STAFF REPORT

Graham Commons Phase I (CR1402)

Type of Request: Conditional Rezoning

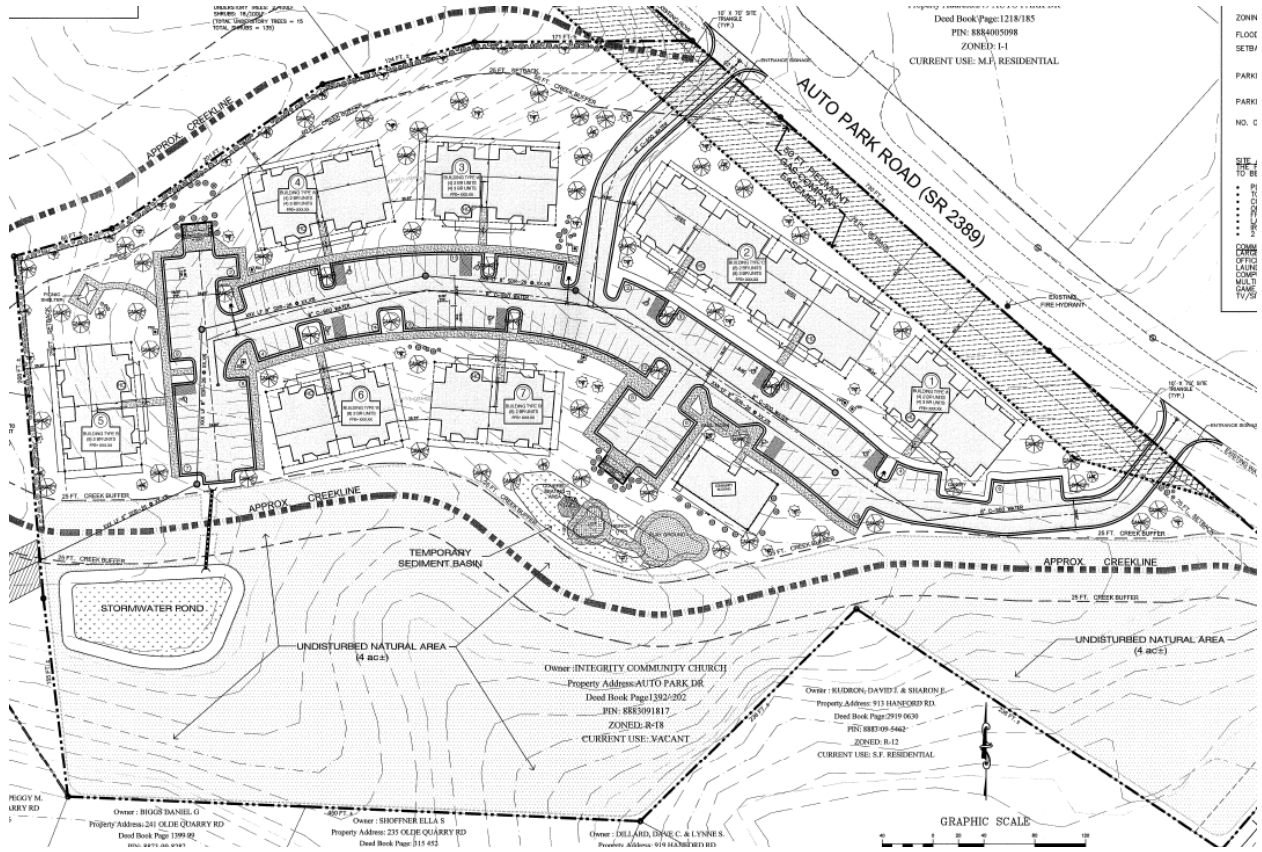
The TRC reviewed the preliminary site plan and met with the applicant on March 10, 2014. The applicant was originally scheduled for a TRC meeting on March 3rd but that meeting had to be rescheduled due to inclement weather. Therefore, staff has not had time to compile all TRC comments and the applicant has not had time to address them as of the writing of this staff report. Some preliminary TRC comments that may impact the overall development include:

- It is likely that alternate landscaping will need to be used along the northern stream and the street yard, due to the stream and the PNG easement
- Consider providing a sidewalk along Auto Park Dr and Hanford Rd
- The riparian buffer for the northern stream is 50 feet from the top of bank; this may impact the location of buildings and parking
- Consider providing only one driveway into the development; preferred location is approximately 75 feet westward from the driveway that is currently proposed closest to Hanford Rd

- Due to the delay caused by inclement weather, all TRC comments will be addressed prior to City Council approval. TRC comments that may change the layout of the development include NCDOT's recommendation for only one driveway and the riparian buffer for the northern stream.
